Addendum #2

project: Intermountain Health Layton Hospital
Sleep Lab Remodel
201 West Layton Parkway
Layton, Utah 84041

ADDENDUM NO. 02

1 MAIN FLOOR DEMO REFLECTED CEILING PLAN

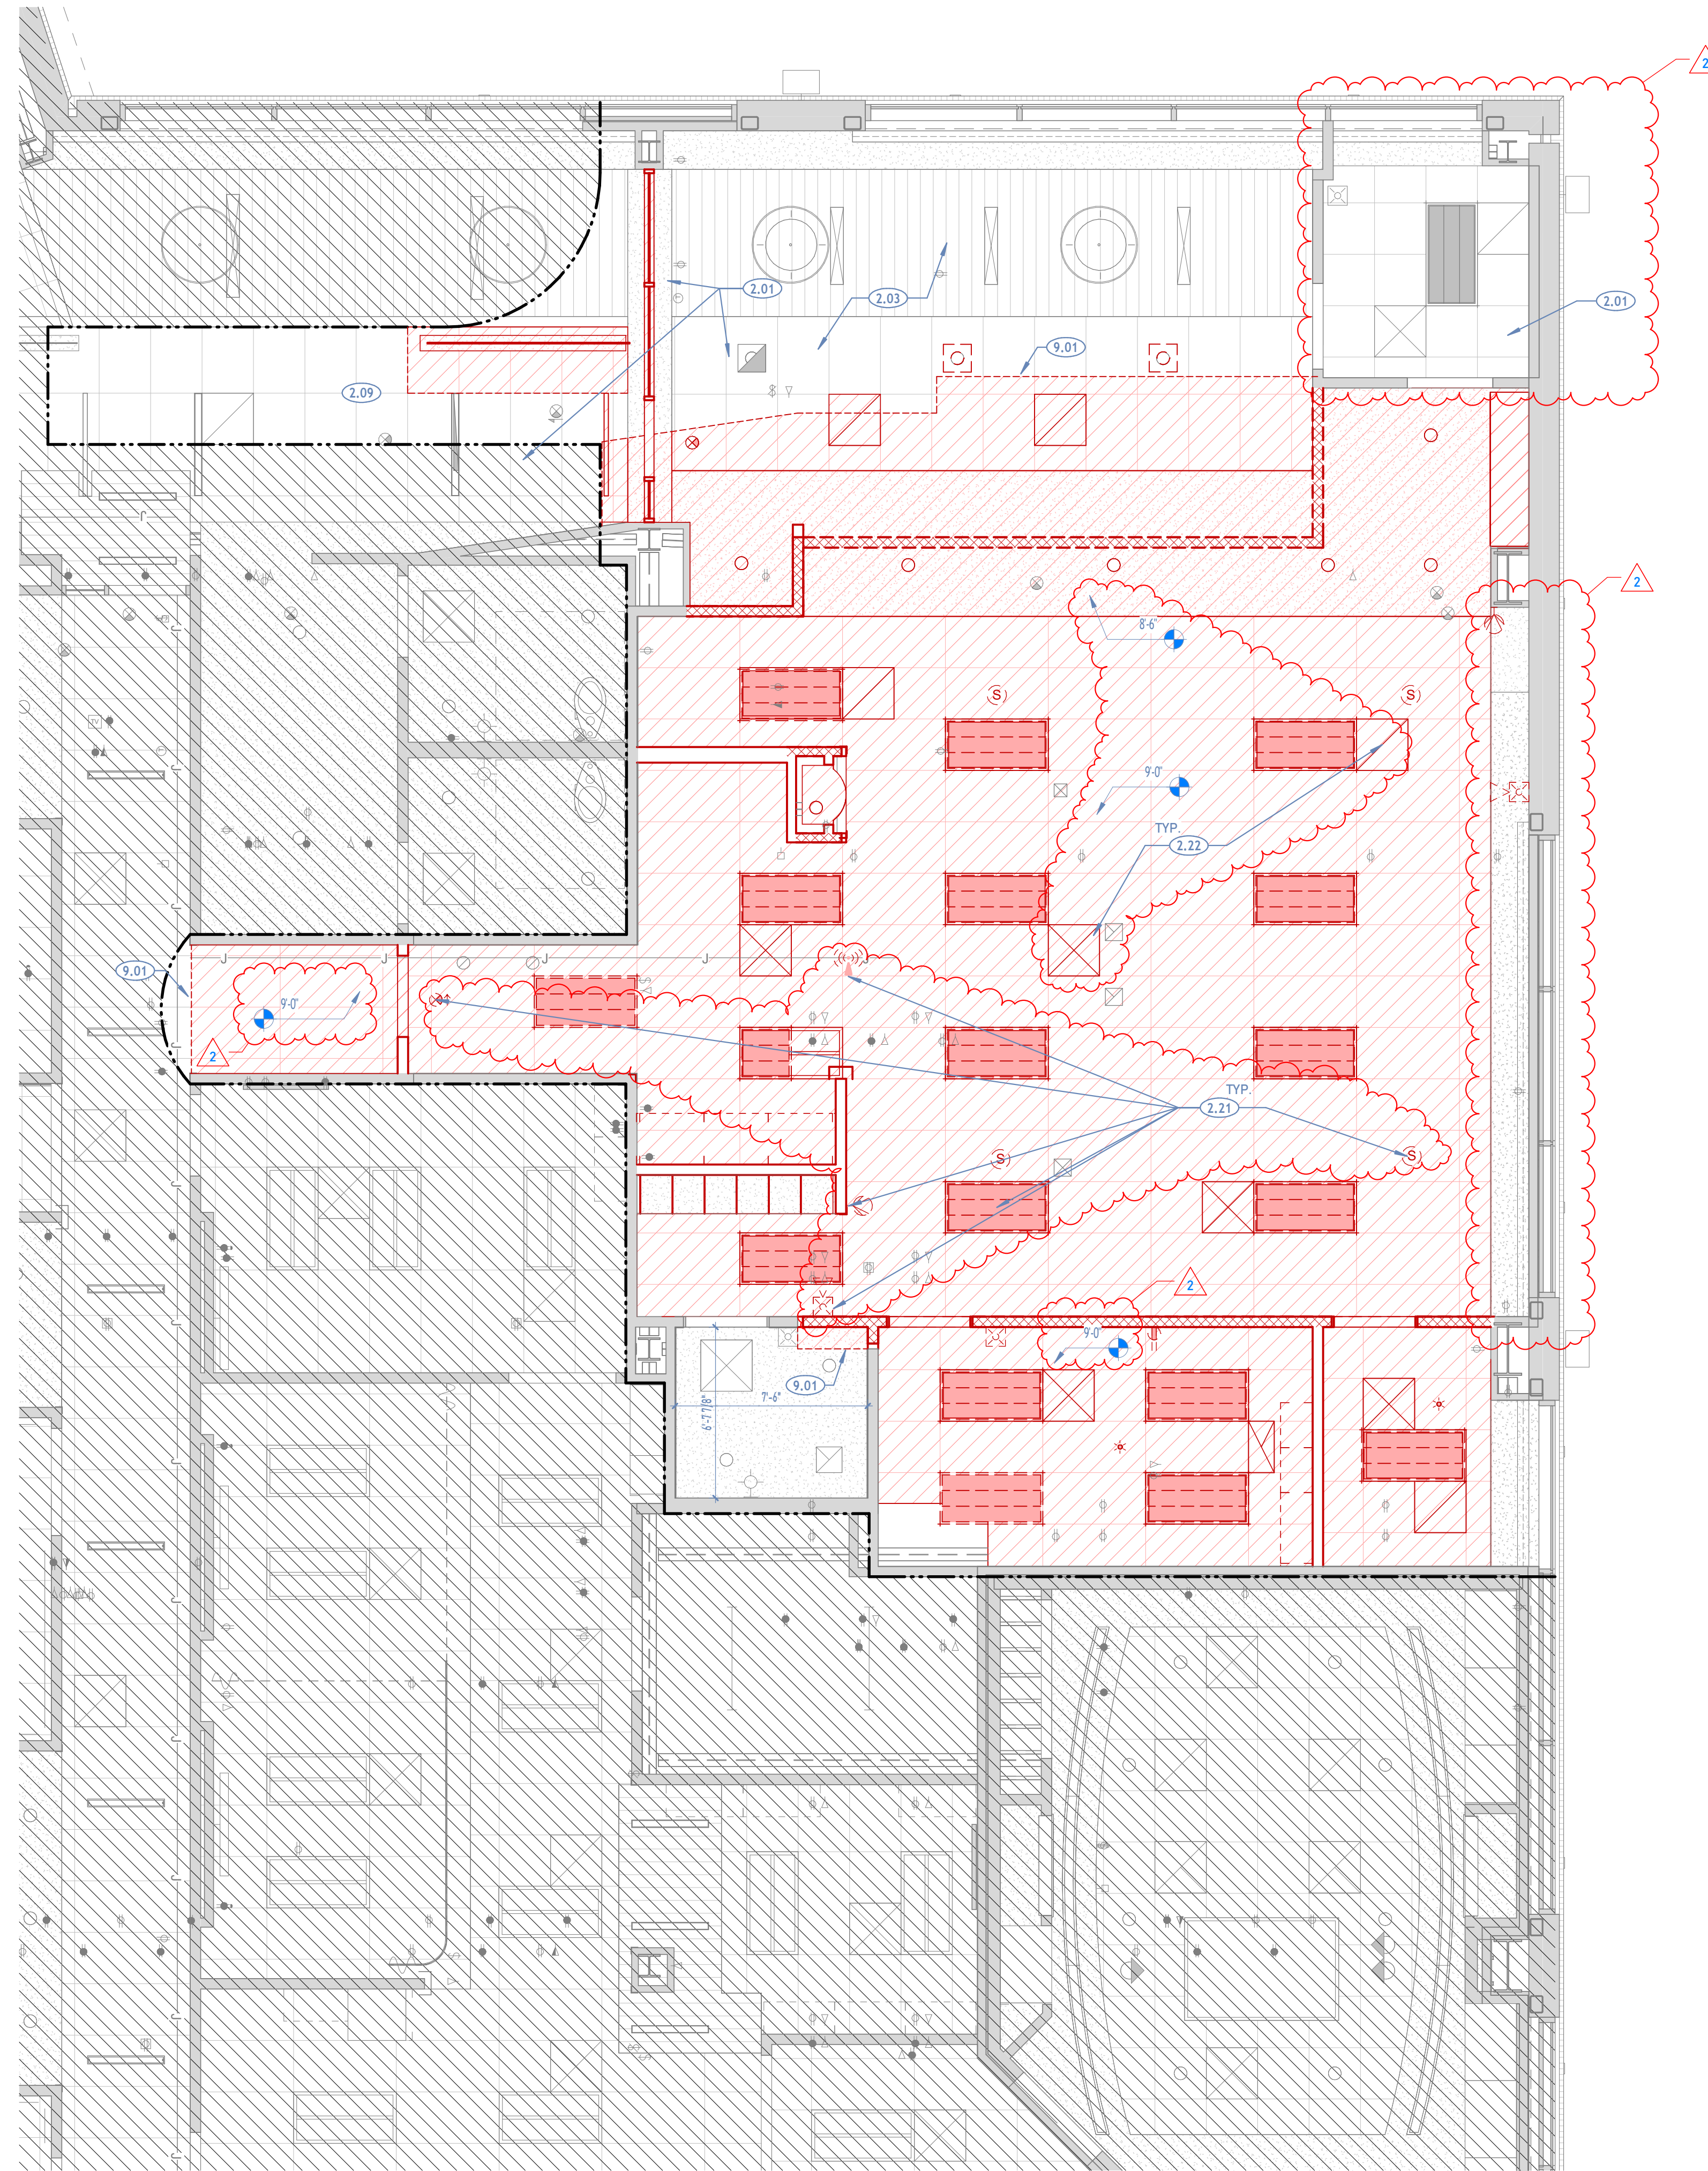
1. On AD102 Ceiling Demolition plan, existing room Consult 002 showed demolishing ceiling and diffusers and new plan showed them as existing to remain. They are to be existing to remain. Demolition plan has been updated.

- On the reflected ceiling plan the gyp ceiling/soffits around exterior glazings is called existing, yet the demo reflected ceiling shows them being demolished.. Can we clarify if these are existing or to be built new?

- If there are some key notes that could be added clarifying the extent of the demo on sheets AD101 and AD102. My demo crew just needs to know what items are what on these sheets such as if its flooring, millwork, brackets, etc and if there could be some added height to determine waste. It also appears there might be some wall mounted items but it is hard to tell what they might be.

- These are to be existing, see updated AD102 Demolition Ceiling Plan.
- Note 9.03 In Sleep 1 & Sleep 2 Room calls for 1 layer of 5/8" drywall on existing wall but does not clarify if it goes to deck or 6" above ceiling height.. Can we clarify this?

- Demolition plans are provided to help show what is to be removed to be able to build the new plan as intended, not every accessory is noted. The hope is that during the pre-bid walk and pictures you can note the existing condition. We have added key notes 2.16-2.24 to try and help explain certain items shown on the plans. See updated AD101 Demolition Floor Plan. Elevations of existing ceilings have been added to AD102 Demolition Ceiling Plan as well.

1 SLEEP LAB FLOOR PLAN
1/A101 | SCALE: 1/4" = 1'-0"

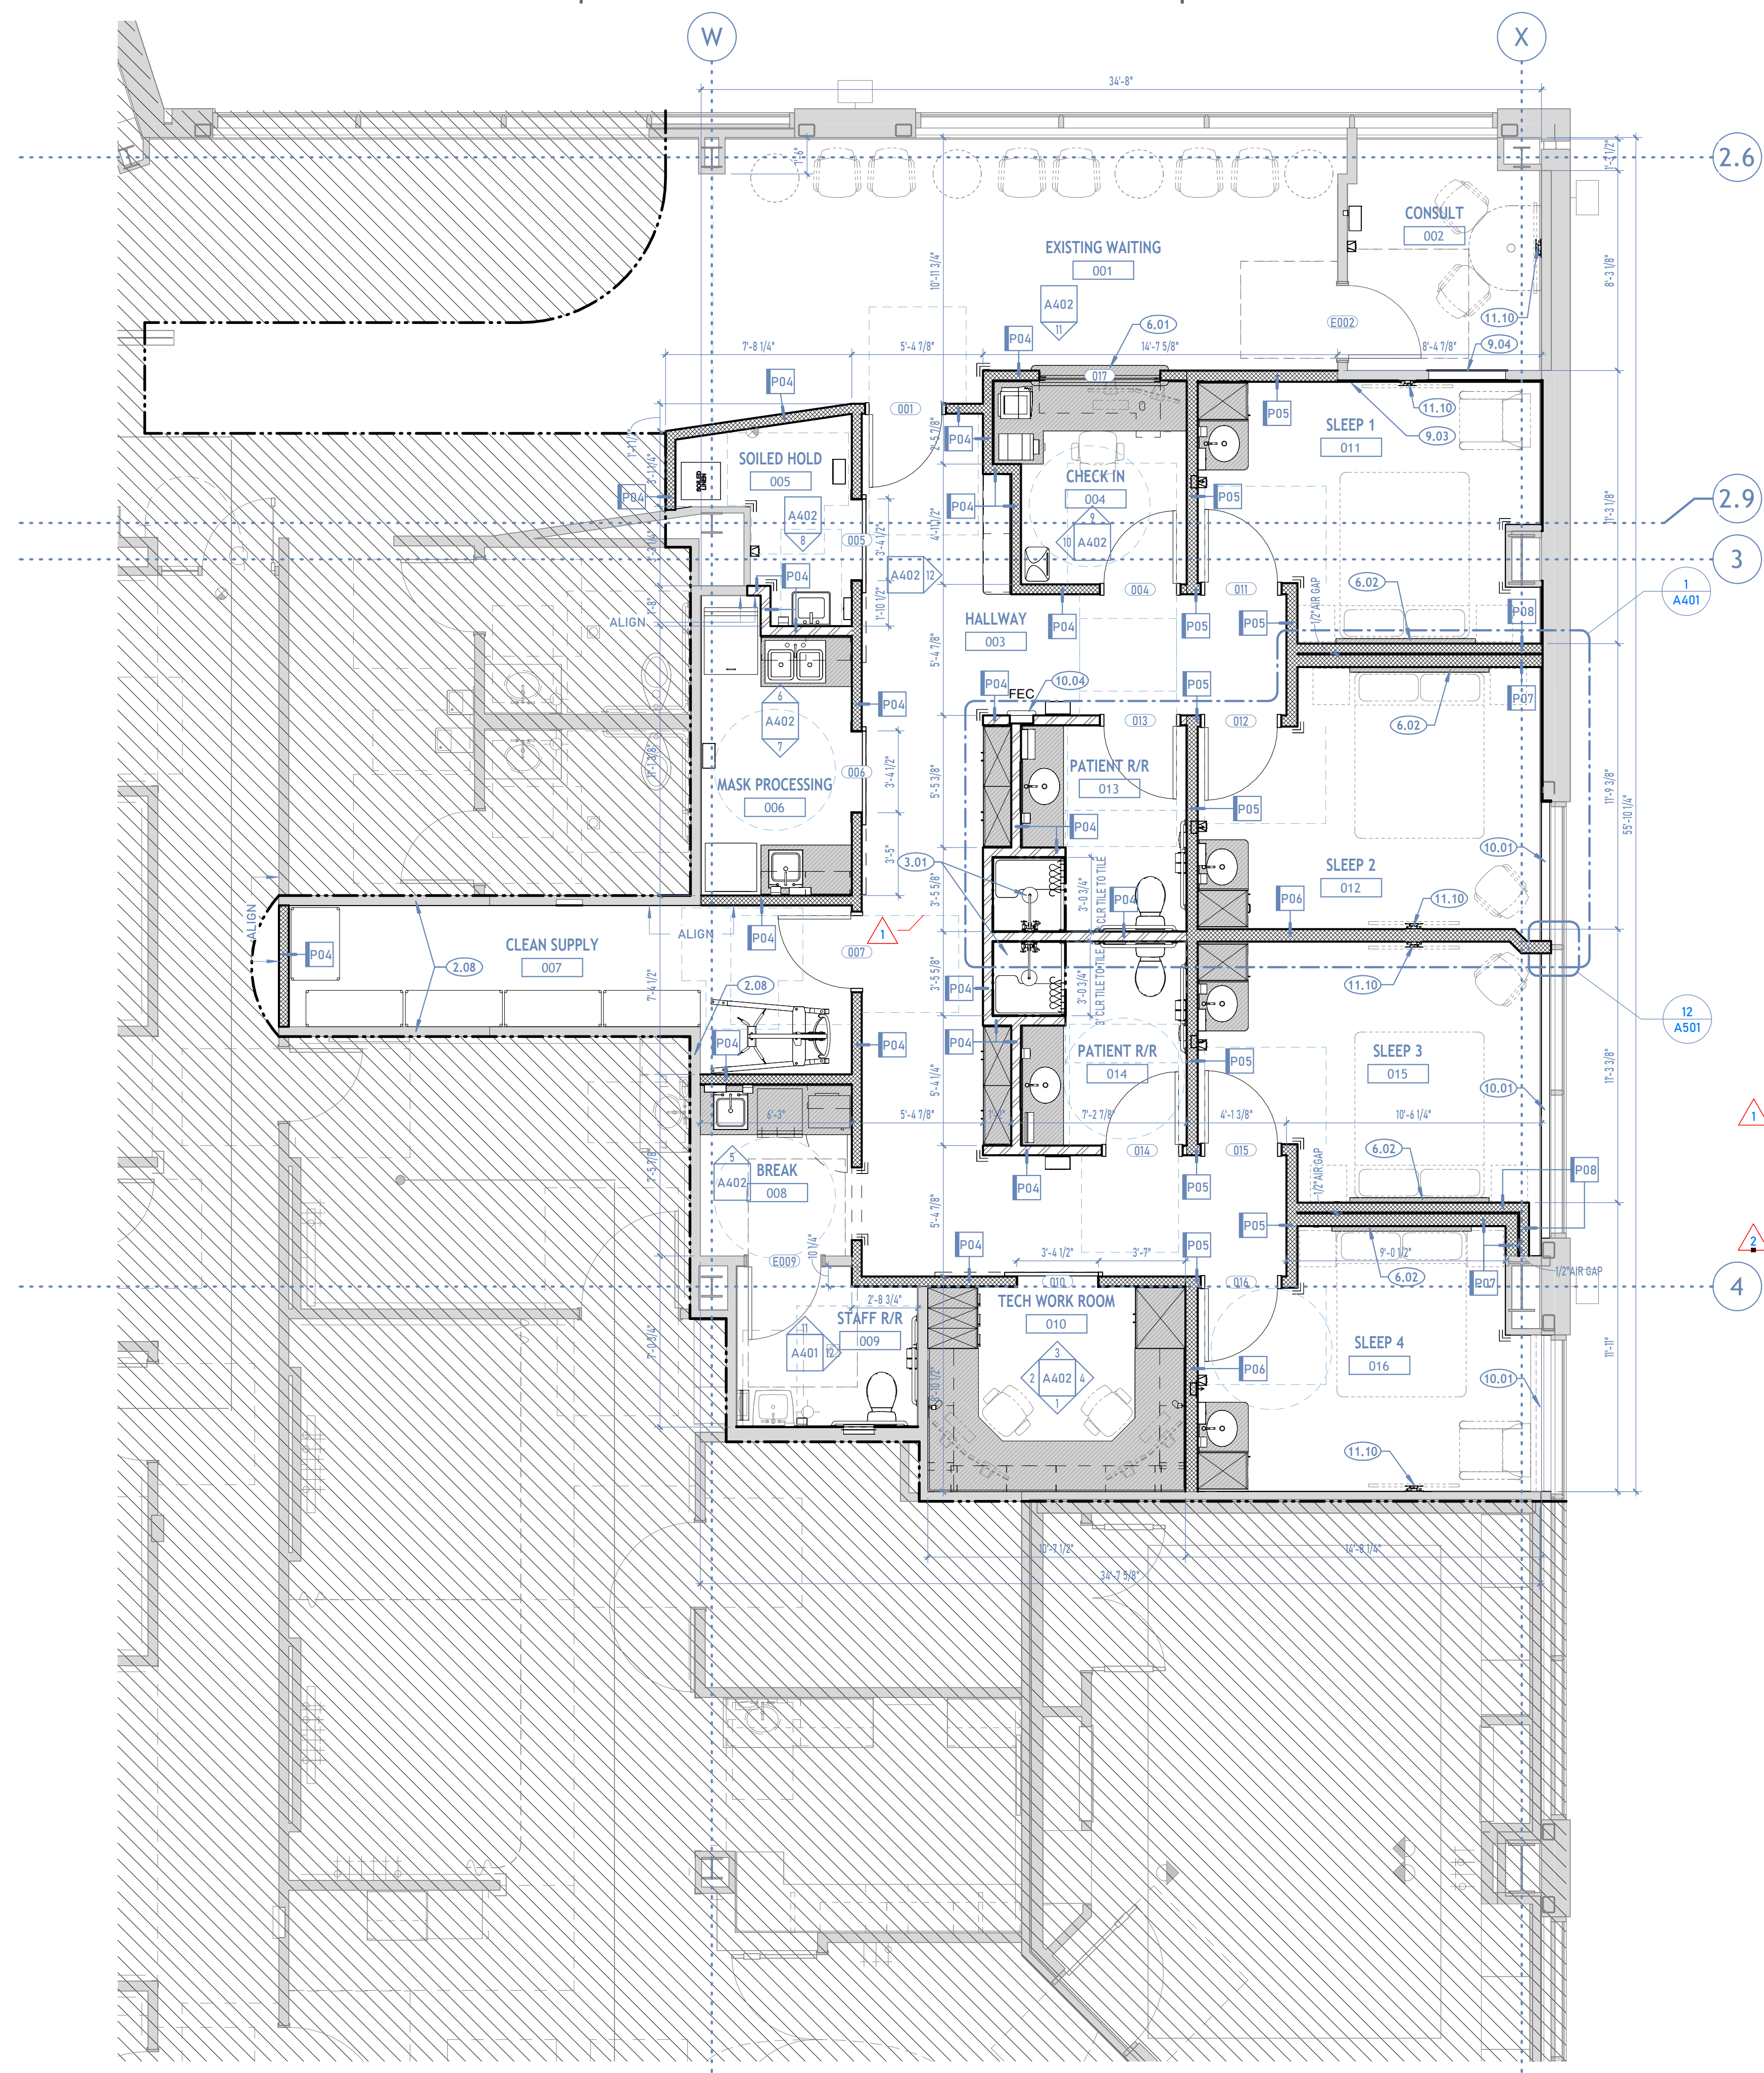
- Note 2.08 on floor plan states to ensure walls are built to resist passage of smoke. Does this wall need modification? If so, is it just drywall or framing as well?

- Framing up to deck and one sided drywall up to deck with UL rated smoke resistant sealant to seal any penetrations.
- 2. Do the upper cabinets & headboards need backing? If so, does flat strap backing meet the requirements?

- Note clarified by adding "Full height to deck." See updated note 9.03 on A101.
- Conflict with CR. EY shows one. Addendum #1 Set 1.0 calls for 3. Are we installing an auto opener on door 001? The hardware set has a standard closer the e sheets show HC plates the schedule also calls for an opener. Are we using wave plates or push plates?
